BCCWIP # 4182, CEDAR LANE WATER SYSTEM, CAPITAL REGIONAL DISTRICT

The Capital Regional District (CRD) has completed water system improvements at its Cedar Lane water system on Salt Spring Island. The following information summarizes the reporting requirements related to the British Columbia Community Water Improvement Program.

Re: W-S-1176 – Cedar Lane Water Works District – 2009 Improvements

Re: Water Construction Permit No. W-S-1230 – Cedar Lane Water System, Saltspring Island

SCHEMATIC CONTROLS & MECHANICAL
 CEDAR LANE WATER SYSTEM
 C/O Environmental Services
 2009

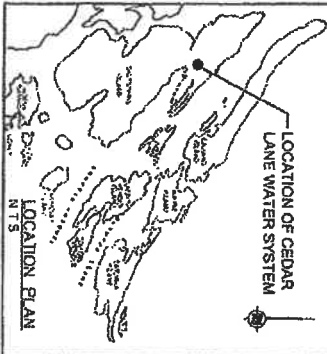
- Need to add - Well #5
- G Valves
 - Instruments
 - Chlorine/Ph sampling lines
 - missing valves & check valves

CEDAR LANE WATER SYSTEM
 2010 UPGRADE - PROPOSED RESERVOIR SITE
 SITE PLAN & LOCATION PLAN
 26-0212-2 1 2 2

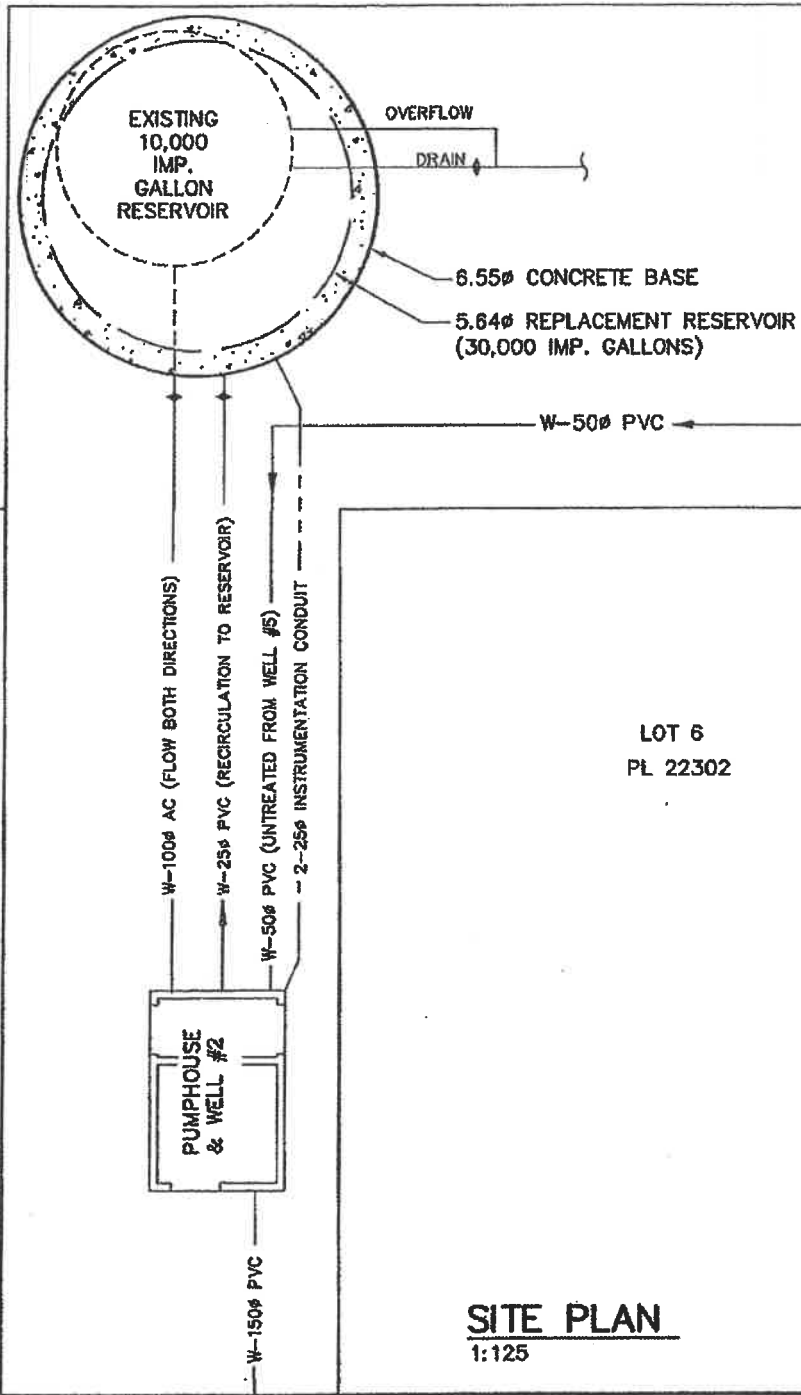
3. CRD shall add the following items to the project and drawings:
 - 3.1. Ensure **erosion protection** is considered downstream of the reservoir drainpipe outlet.
 - 3.2. Provide at least a 2 m. x 2 m. **concrete apron** in front of the ground-level "access hatch" to create a "clean zone" for placing disinfected clothing and boots etc. during maintenance.
 - 3.3. Please ensure all **normally-closed valves** are labeled accordingly on the construction drawing sets.
 - 3.4. **Ensure separate inlets and outlets** are provided for in the base design of the reservoir, with their piping to extend at least 3 m. beyond the edge of the circular concrete base.
 - 3.5. **Add a riser pipe** for the spare inlet shown as a spare inlet/outlet.

4. CRD to provide at commissioning or in the first three months of operation, a Reservoir Section View sketch or equivalent as a **Plan of Record** showing:
 - 4.1. The base tank elevation (metric) and the top TWL elevation (metric)
 - 4.2. To show the various alarm/floats and the their relative elevations
 - 4.3. The bottom elevation of the domestic storage c/w text on its volume listed in cu.m. and (Igal.)
 - 4.4. The bottom of the fire storage c/w text on its volume listed in cu.m. and (Igal.)
 - 4.5. The bottom of the emergency storage c/w text on its volume listed in cu.m. and (Igal.)
 - 4.6. The dead space storage below the outlet rim elevation listed in cu.m. and (Igal.)
 - 4.7. The total storage in cu.m. and (I. gal.)
 - 4.8. The gauge/thickness of the panels supplied at the various ring levels.
 - 4.9. The paint specifications and the steel finishing specifications.
